STAFF RECOMMENDATION
506 Acklen Park Drive
November 15, 2017

Application: New construction - infill
District: Richland-West End Addition Neighborhood Conservation Zoning Overlay
Council District: 24
Map and Parcel Number: 10401040100
Applicant: Ke Qin, owner
Project Lead: Melissa Sajid, melissa.sajid@nashville.gov

Figure 1: 506 Acklen Park Drive

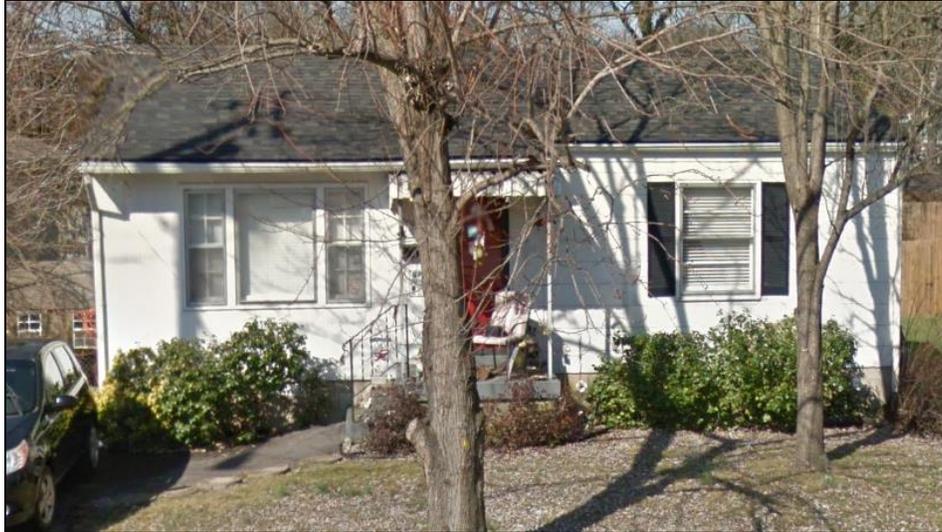
Analysis and Findings: Application is to construct duplex infill. The carport shown on the site plan is not included with the application at this time.
